**LAND COURT OF QUEENSLAND****REGISTRY:** Brisbane**NUMBER:** EPA495-15

**Applicant:** **New Acland Coal Pty Ltd ACN 081 022 380****AND****Respondents:** **Frank Ashman & Ors****AND****Statutory Party:** **Chief Executive, Department of Environment and Heritage Protection****SUPPLEMENTARY STATEMENT OF EVIDENCE TO THE LAND COURT BY BRIAN GEORGE BARNETT****1. Expert details and qualifications****1.1 Name**

**Annexure A - Memorandum in response to Second Supplementary Statement of Evidence of Dr Matthew Currell and Professor Adrian Werner**

**From** Brian Barnett  
**Subject** Response to Second Supplementary Statement of Evidence

**Figure 1 : Measured groundwater levels in Bore #42231395 and Bore #42231530**

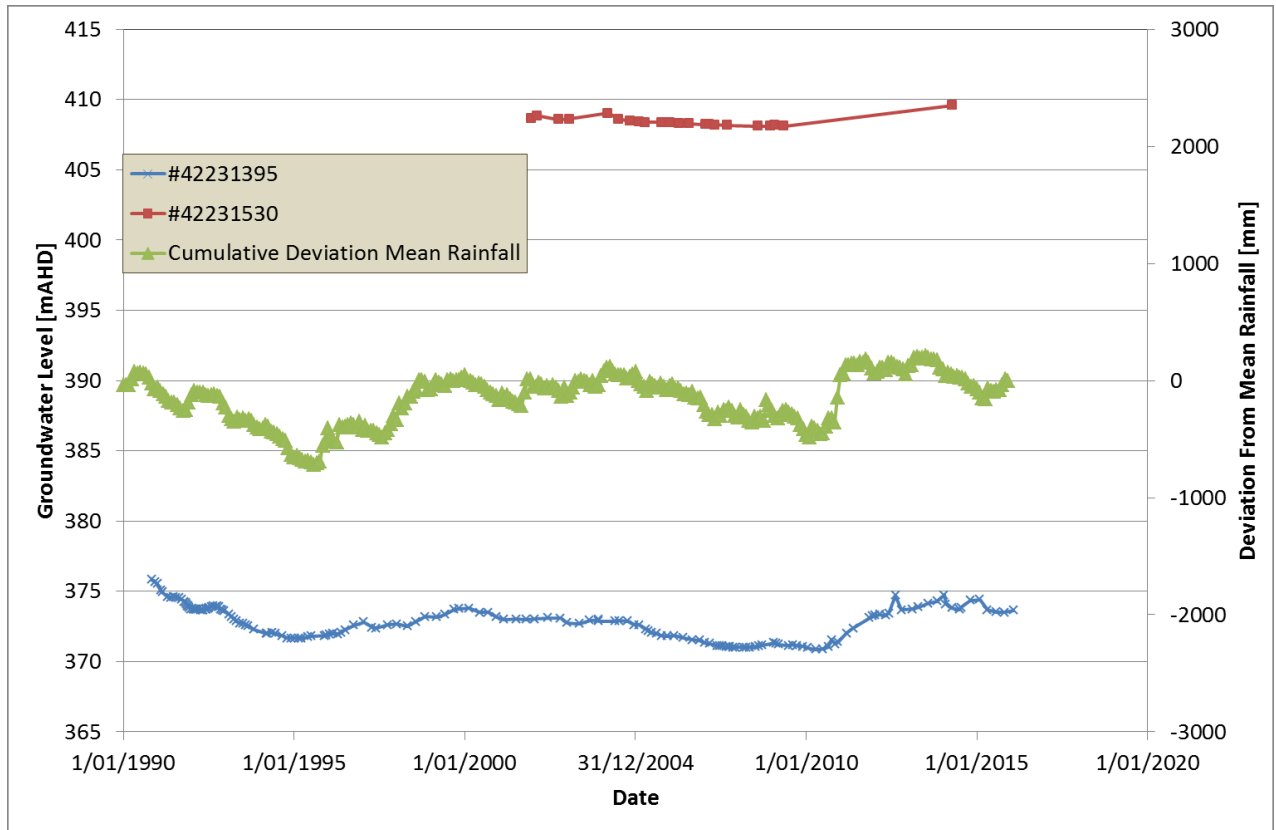
Professor Werner and Dr Currell further claim that water levels in Bore #42231395 may be impacted by drawdown associated with nearby groundwater extraction including that from Bore #83211, being an extraction well used by the Oakey Abattoir.

The recorded groundwater heads in Bore #42231395 and Bore #42231530 are presented below in Figure 1. The measured water levels in Bore #42231395 show no obvious influence of drawdown from nearby pumping. There are long term fluctuations in head measured in this bore and the likely explanation for this is rainfall variability over the period of record.

Figure 1 also includes a plot of the cumulative deviation from mean rainfall (CDMR) as calculated from recorded rainfall between 1990 and 2016 at BOM station 41359, Oakey Aero. The CDMR is a useful tool for illustrating trends in rainfall with time. The CDMR rises during periods of above average rainfall and falls during periods of below average rainfall. A comparison between the CDMR and the measured levels in Bore #42231395 shows a direct correlation between the groundwater level measured in this bore and periods of higher than average and lower than average rainfall. In other words there is no clear evidence that would suggest that the groundwater levels in this bore have been influenced by groundwater extraction.

**Figure 2 : Schematic representation of the model layers and hydrogeological units included in the 2009 model.**

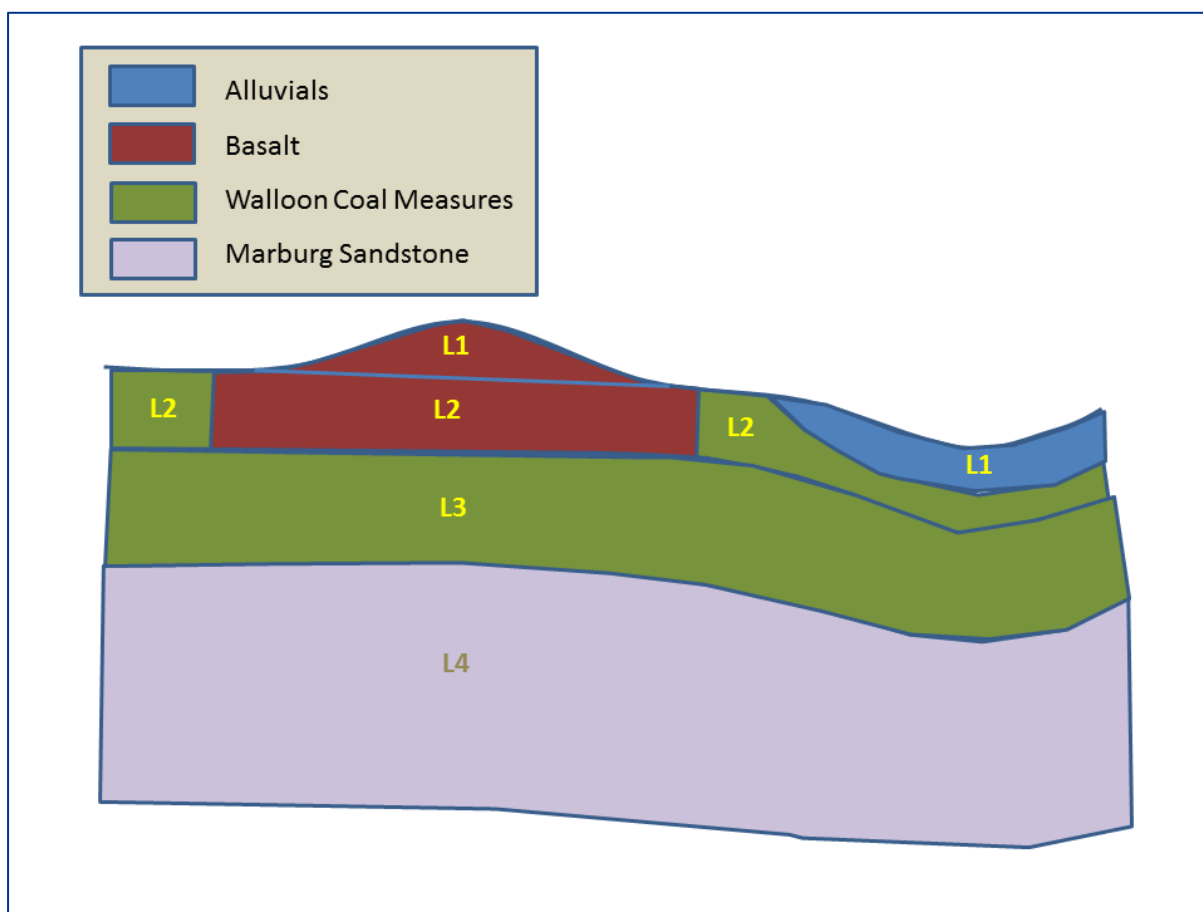
Professor Werner and Dr Currell provide a simplistic description of the model layer structure used in the 2009 version of the model, which has been dealt with previously in evidence<sup>20</sup>. They focus on the fact that the Walloon Coal Measures and Basalts are represented in a single model layer. They ignore the fact that there are, in fact, four model layers and that there is nowhere in the model where a model cell is required to represent two or more hydrogeological units. The model structure used in 2009 allows for an explicit and unambiguous representation of the hydrogeological units mapped at the site with a level of accuracy that is consistent with the available data. Figure 2 shows a schematic representation of the model layers in a vertical cross section through the model.

The misconception of the model structure appears to have been initiated by Dr Currell in his evidence<sup>21</sup>. I have addressed the issue previously in evidence<sup>22</sup>.

**Figure 3 : Predicted drawdown in the Walloon Coal Measures in 2042 (as shown in Figure 4-3 of SKM, 2009<sup>27</sup>).**

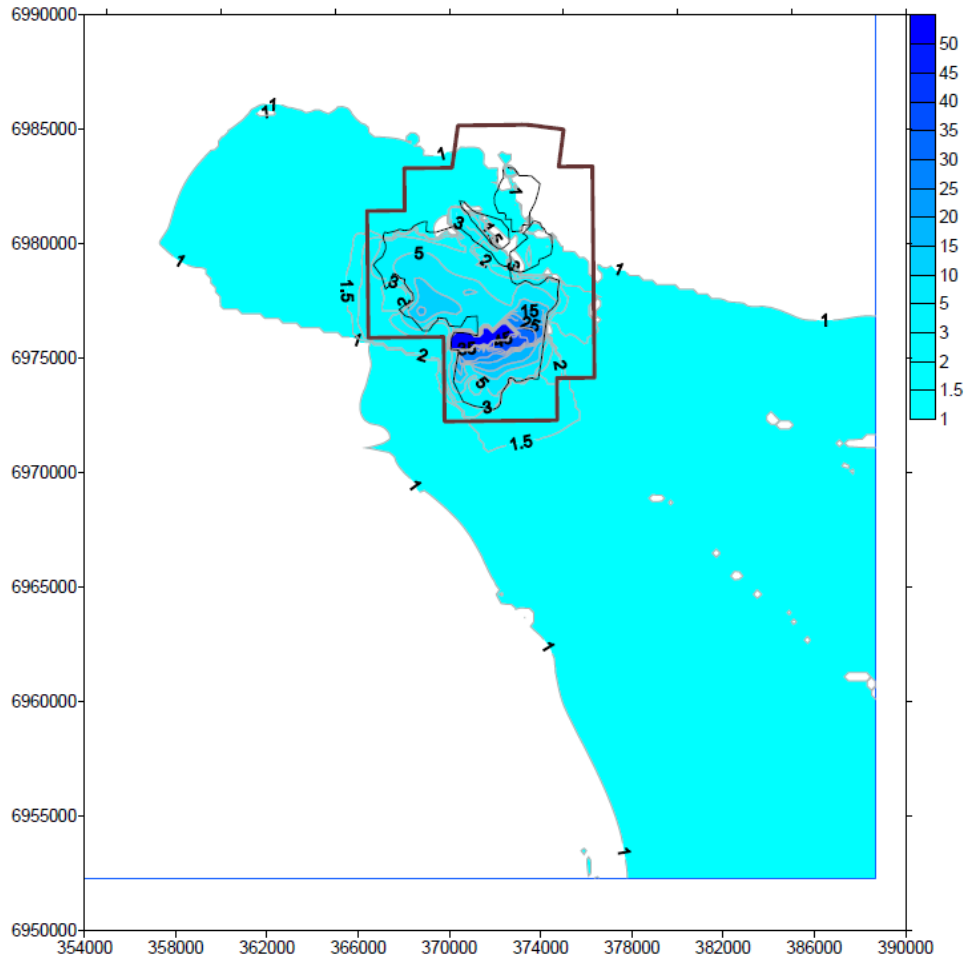
**Item 6.1.** Under cross examination by Mr Holt, I indicated that in the 2009 version of the model, the drawdown did not extend to most of the walls (horizontal flow barriers) included in the model<sup>23</sup>. This statement is mostly correct as shown in Figure 2 of the Second Supplementary Report (reproduced below as Figure 3). This figure illustrates predicted drawdown in 2042 at the completion of the planned mining operations.

Firstly it is clear from Figure 3 that the 1 m drawdown contour extends to the locations of most of the faults. My response would have been more correct if I had qualified my statements by referring to drawdown in excess of 5 m was predicted not to reach most of the faults.

Secondly, Figure 3 suggests that small levels of drawdown (in the region of 1 to 2 m) are predicted to reach some of the fault locations by 2042. I understand that some confusion has arisen from the fact that the 2009 report<sup>24</sup> includes two versions of this drawdown map. One is presented as part of Figure 4-2<sup>25</sup> and the other as Figure 4-3<sup>26</sup> in that report. Figure 4-3 is shown below as Figure 3 and it also shown as Figure 2 in the Second Supplementary Report. It includes contours of drawdown that are less than 5 m. The other version of the prediction is presented as part of Figure 4-2 of SKM 2009 and is shown below as Figure 4. The results are presented with no contours between 1 m and 5 m of drawdown.

When discussing this matter under cross examination, I did not have these figures in front of me and I was relying on my memory. Had I been shown Figure 4-3, I would have been able to provide a more accurate response to the questions.
